Date: September 11th, 2024

Project: All Seasons Arena Renovation	City Project No.: 11075 State Project No.:
Contractor: Met-Con Construction	Date of Contract:

Description: Change Order 006 –

A1-21

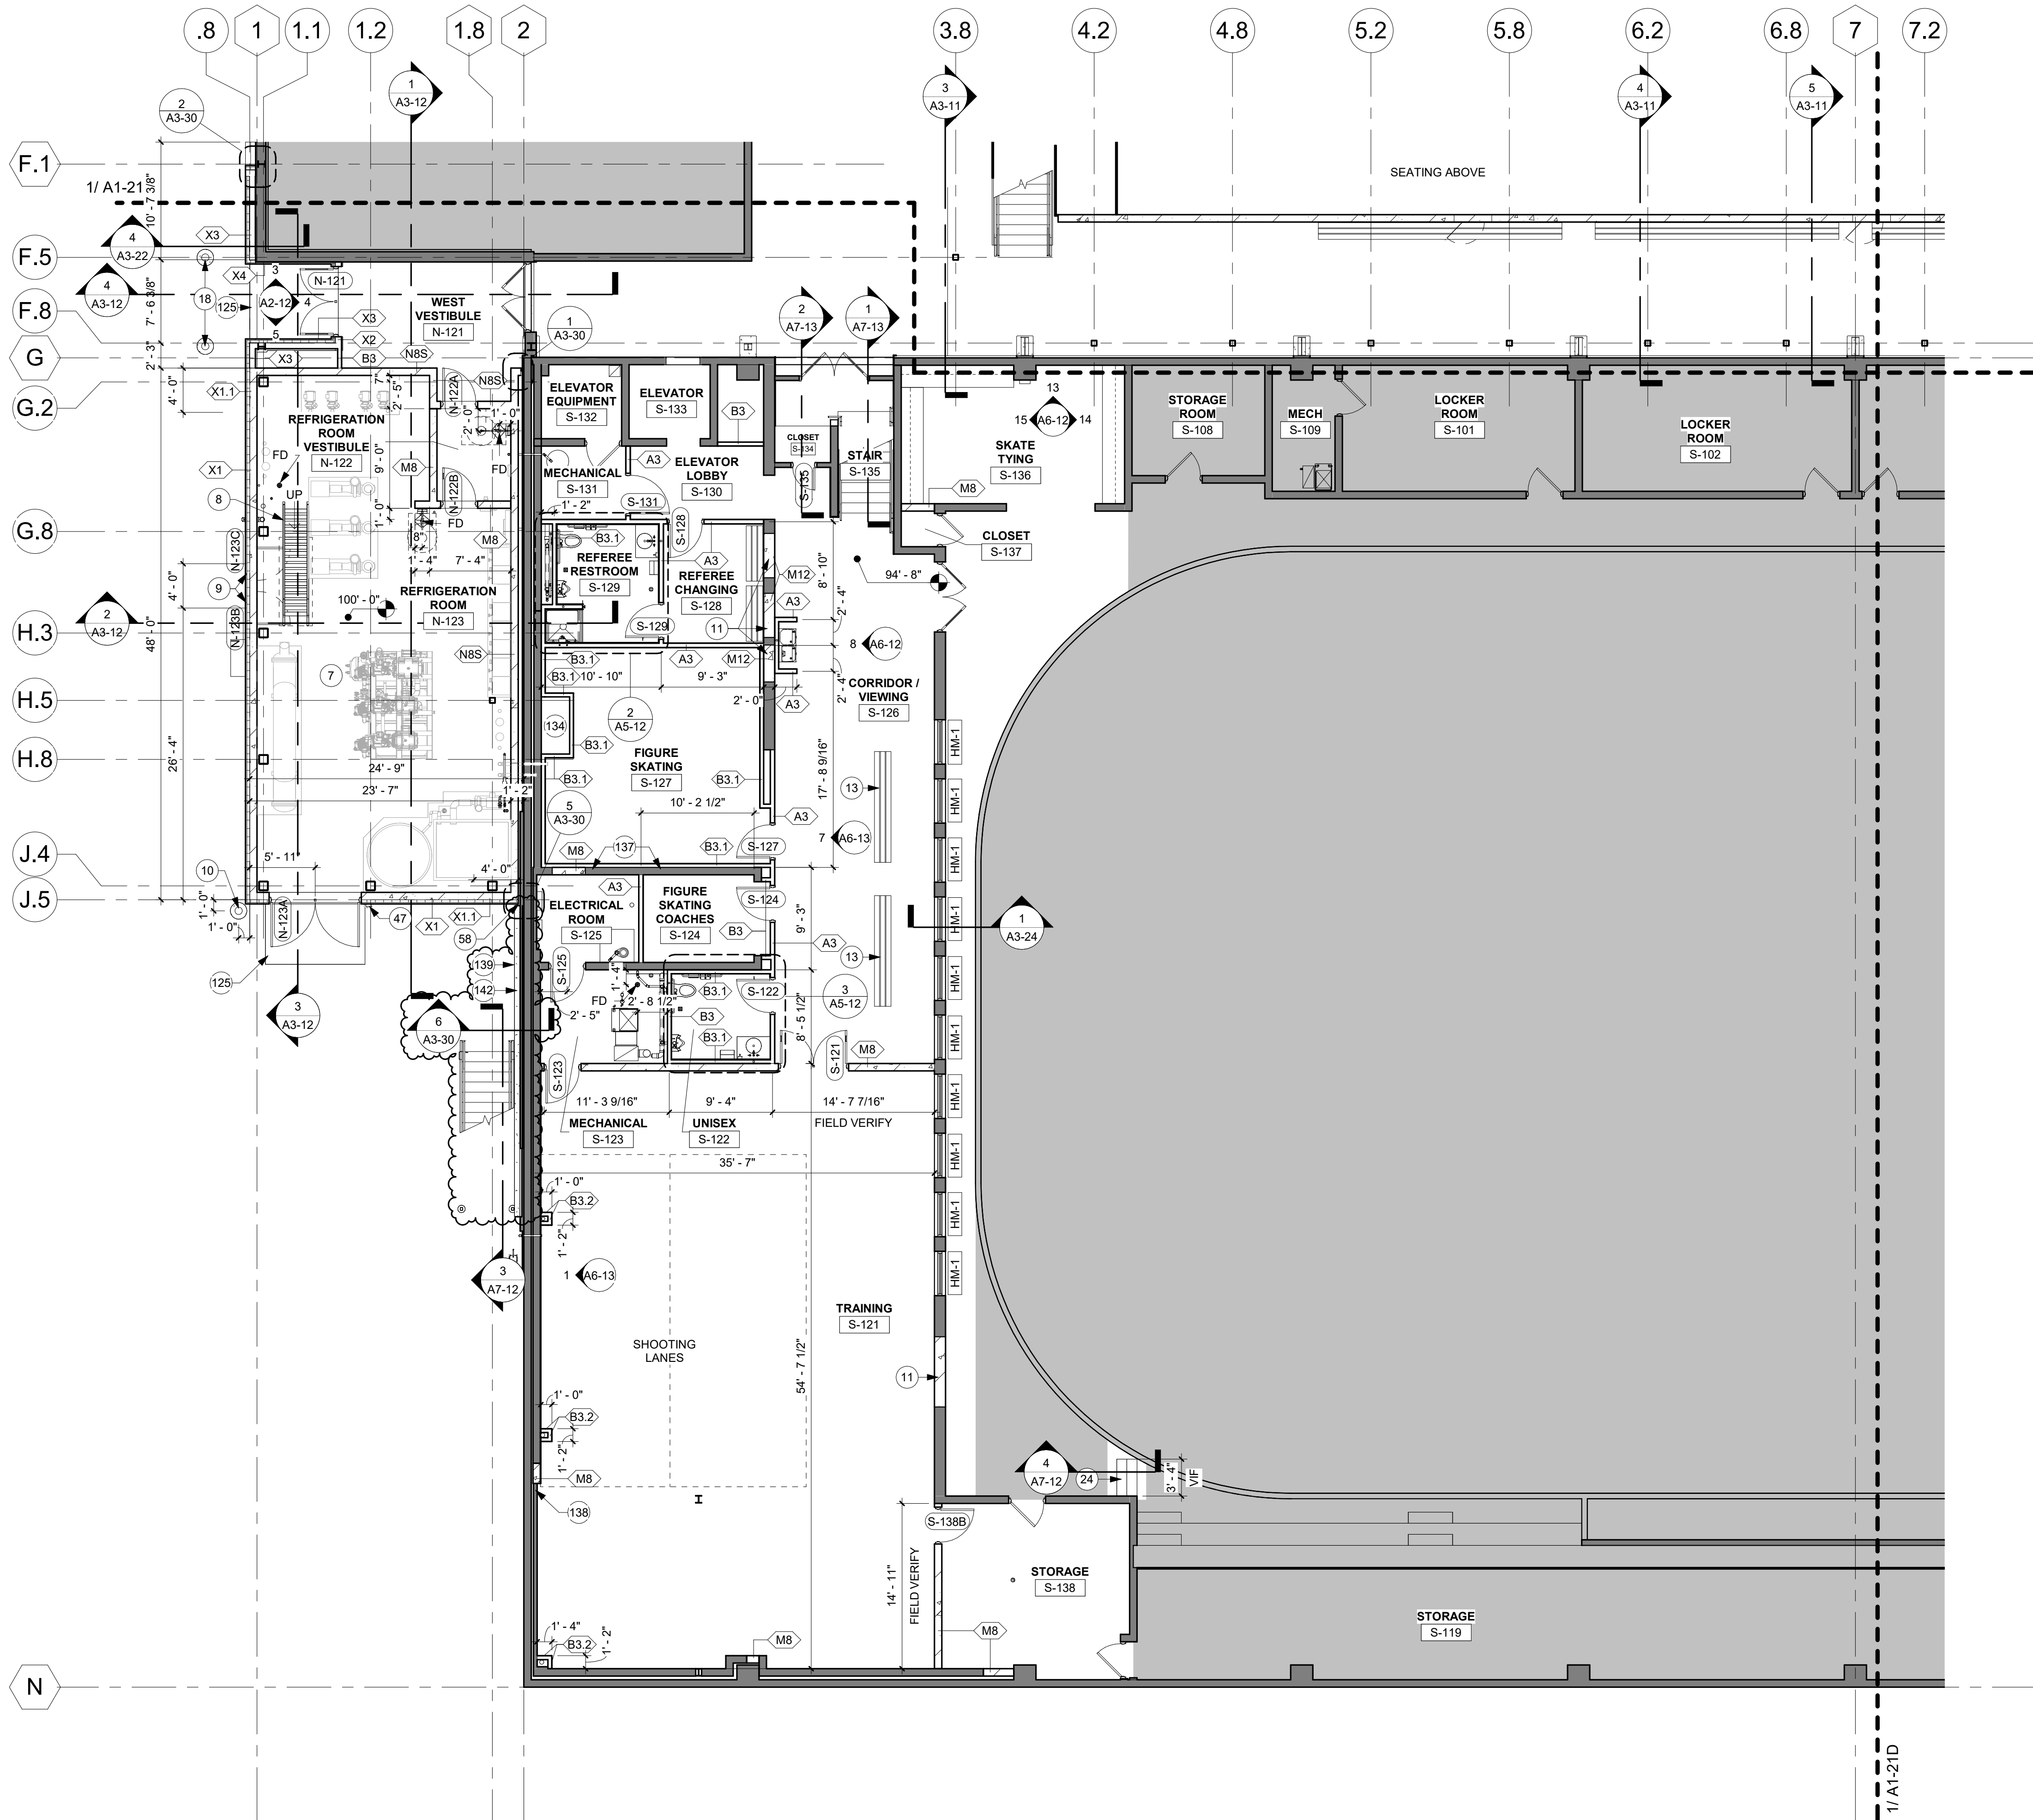
1. Refer to revised Plan Sheet A1-21 – First Floor Plan – Overall
 - a. Revised west stone wall and west stair of the South Rink.
2. Refer to revised Plan Sheet A1-21C – First Floor Plan – Area C

FIRST FLOOR PLAN - AREA C

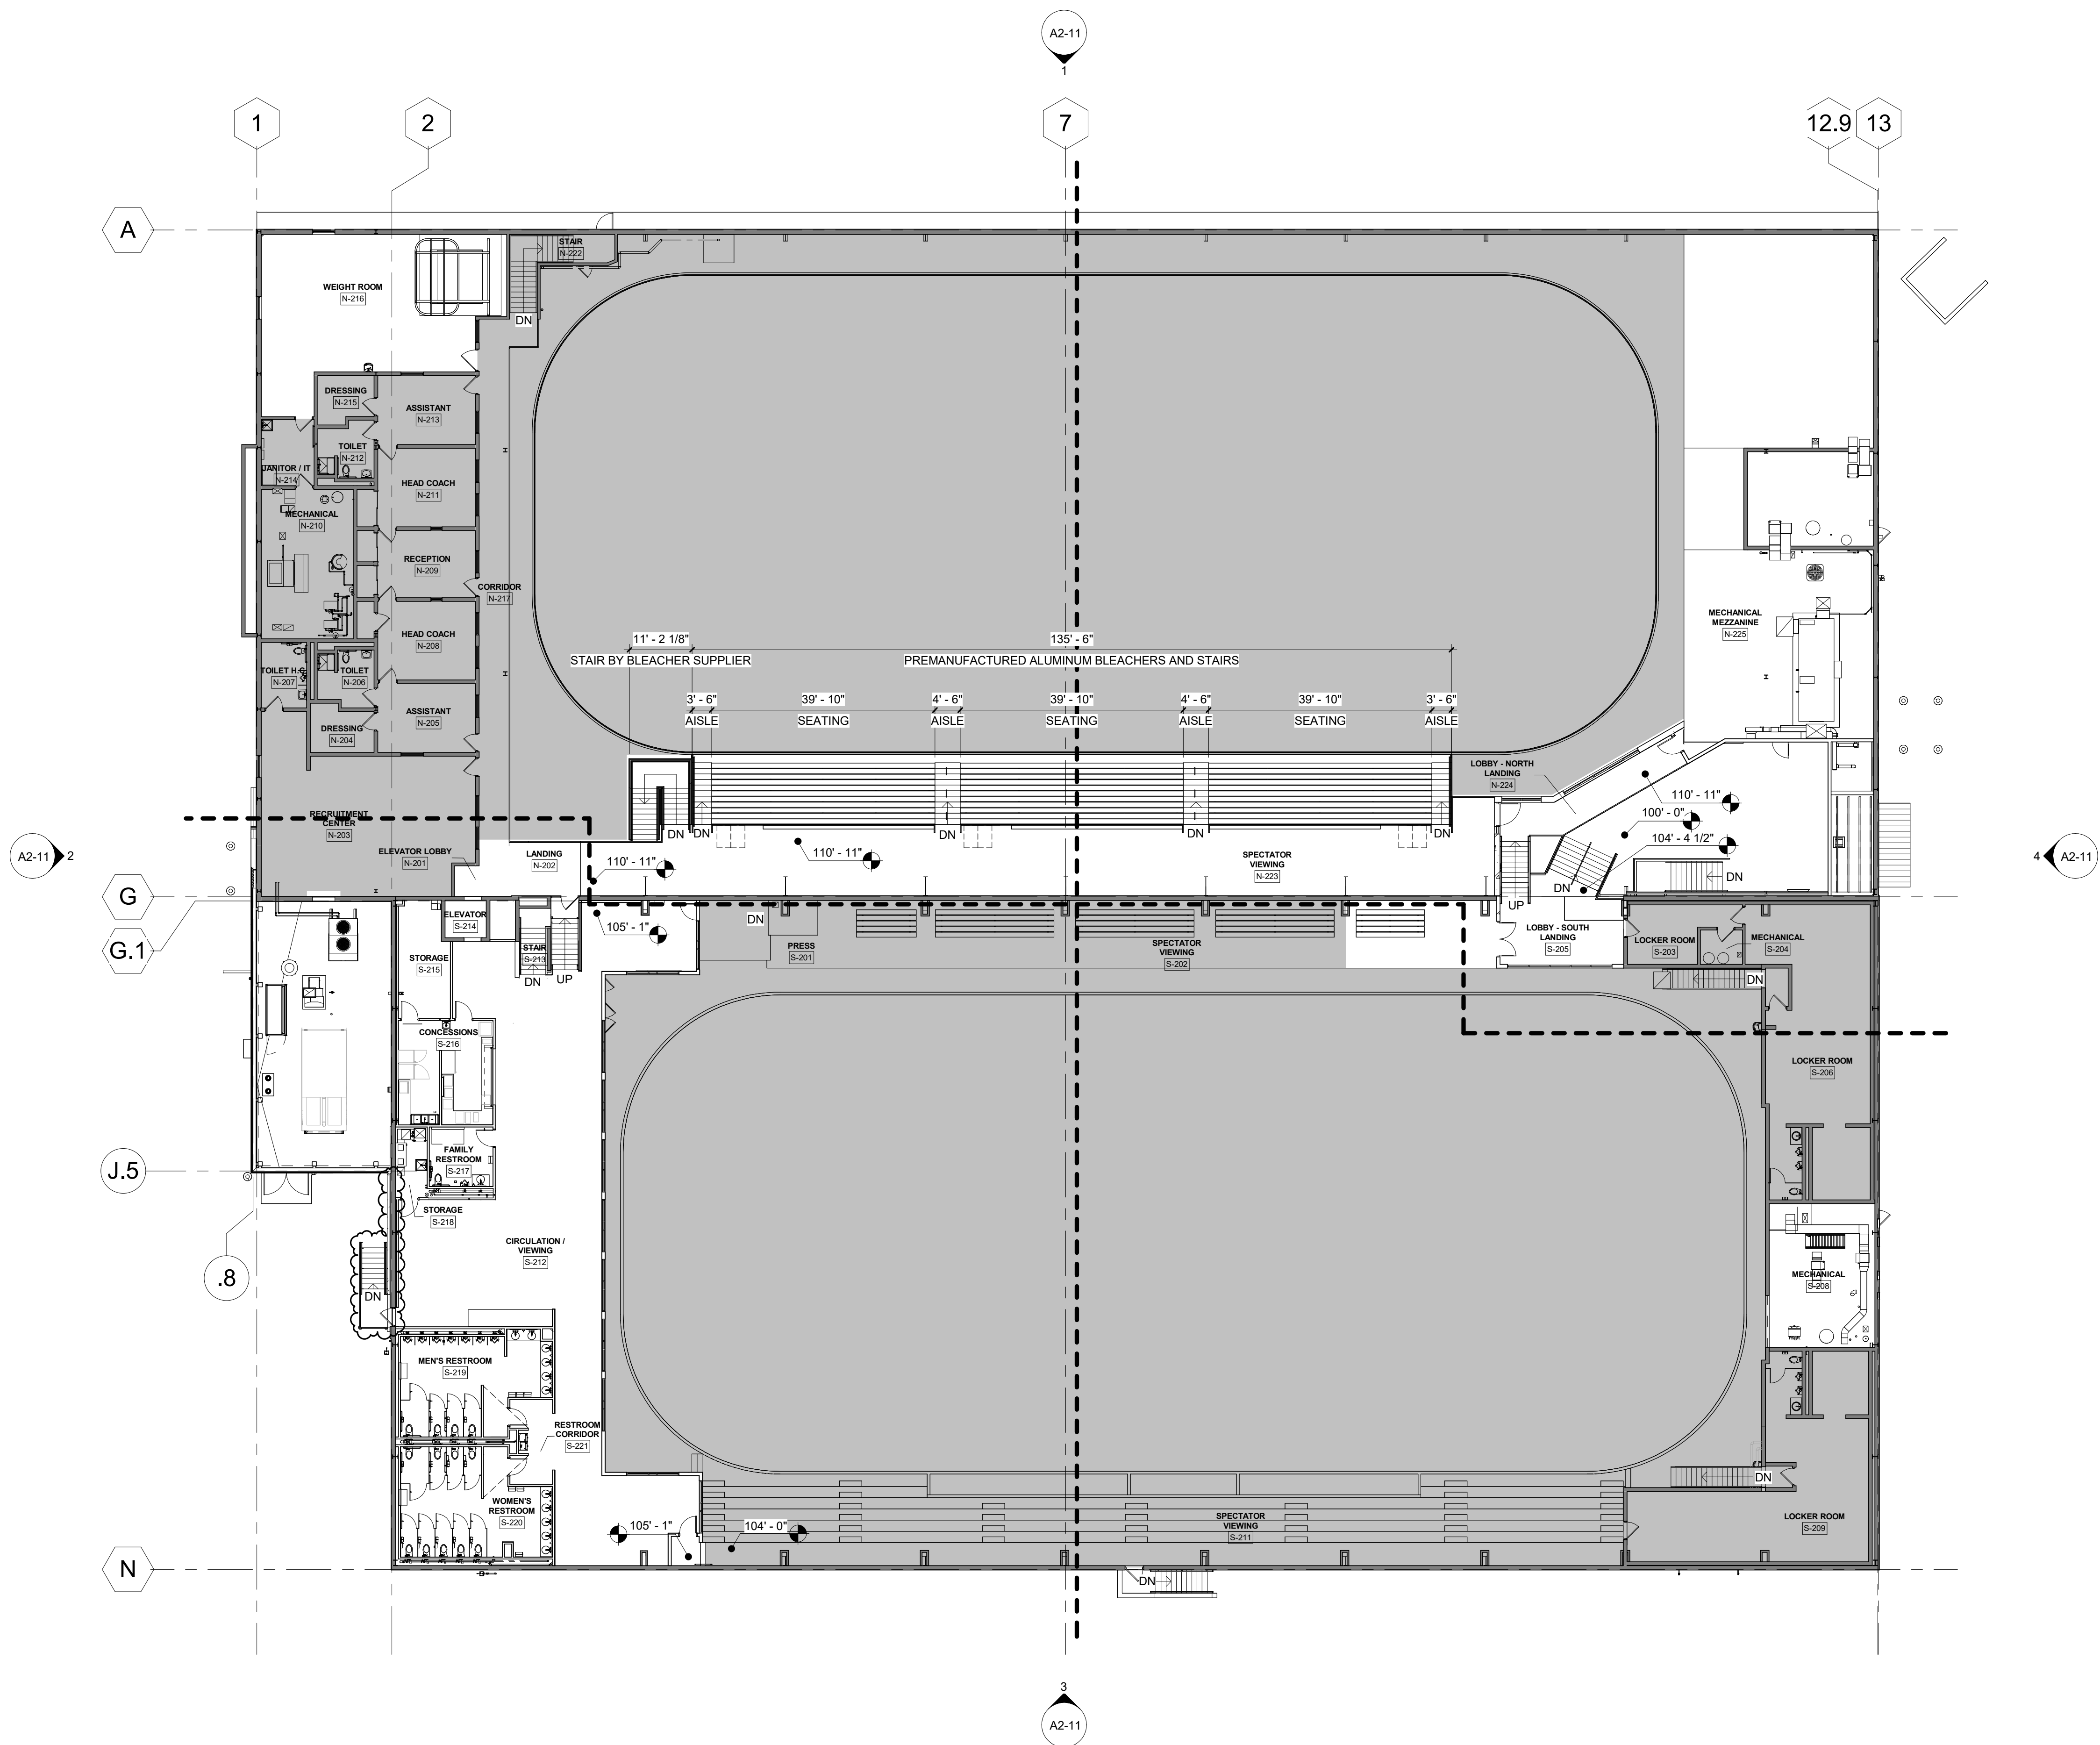
- a. Revised west stone wall and west stair of the South Rink.
 - b. Added keynotes 139 and 142.
 - c. Added detail callout 6/A3-30.
3. Refer to revised Plan Sheet A1-22 – Second Floor Plan – Overall

A1-22

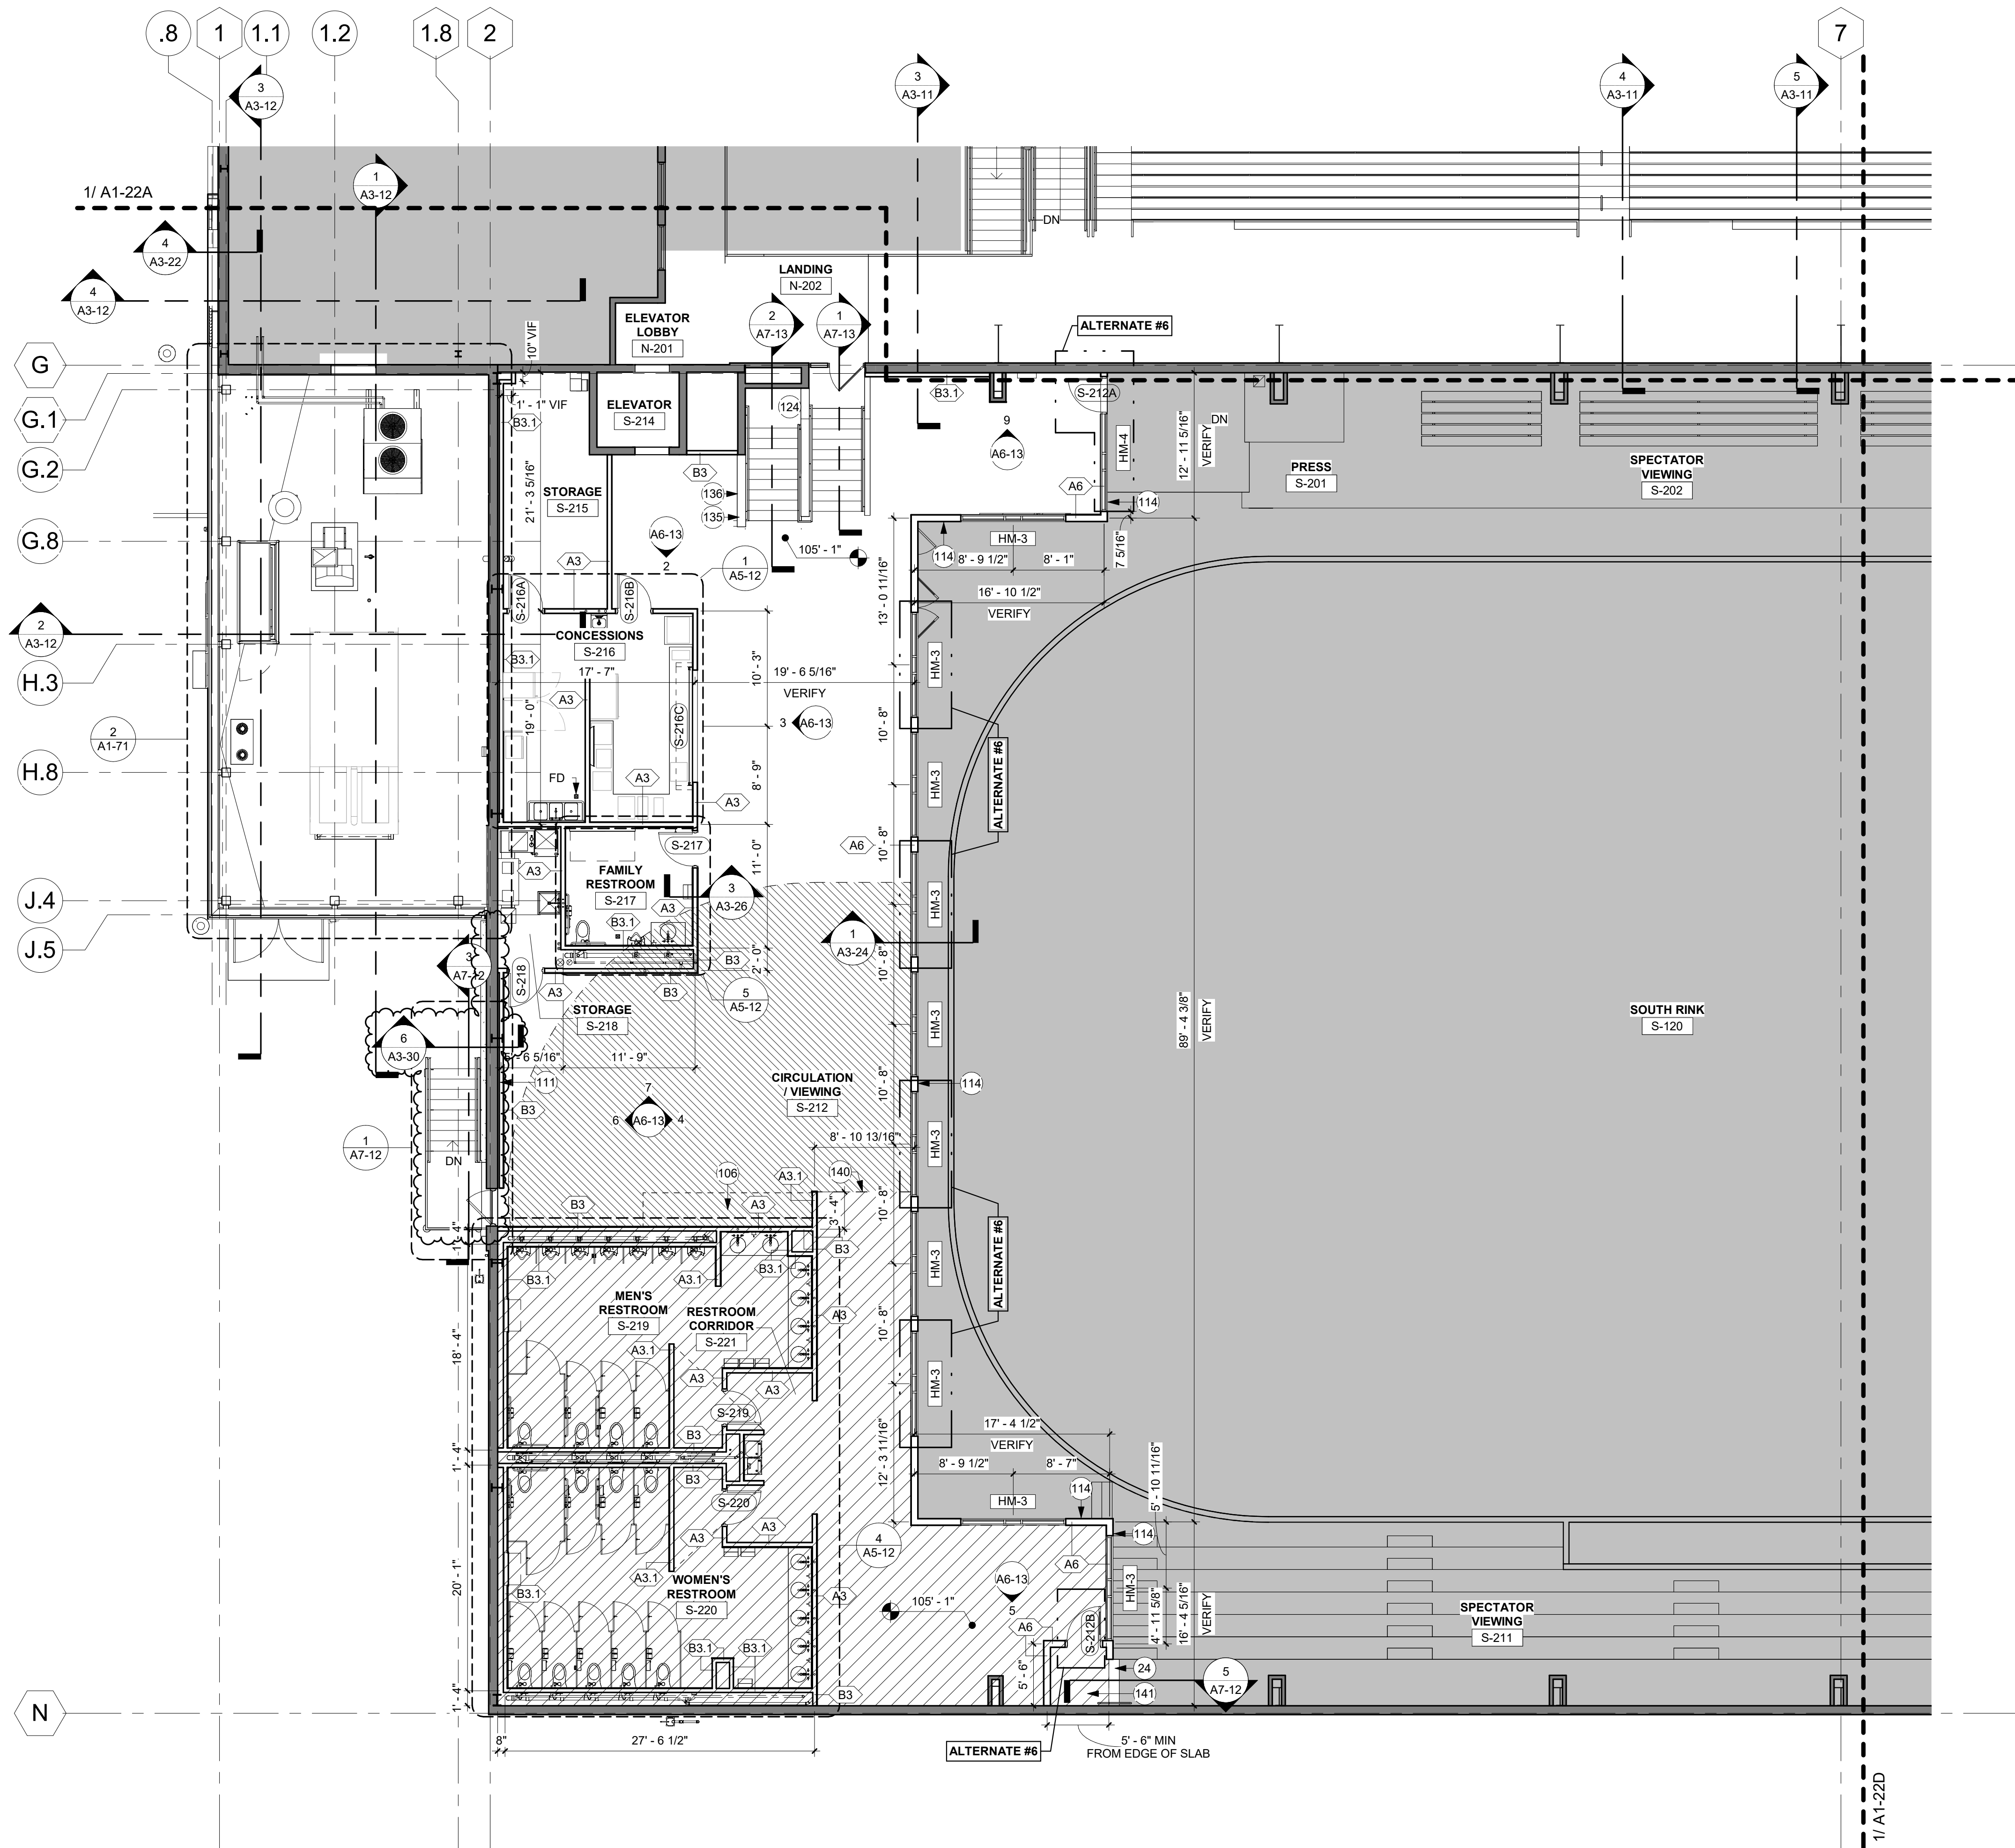
- a. Revised west stone wall and west stair of the South Rink.
4. Refer to revised Plan Sheet A1-22C – Second Floor Plan – Area C
 - a. Revised west stone wall and west stair of the South Rink.
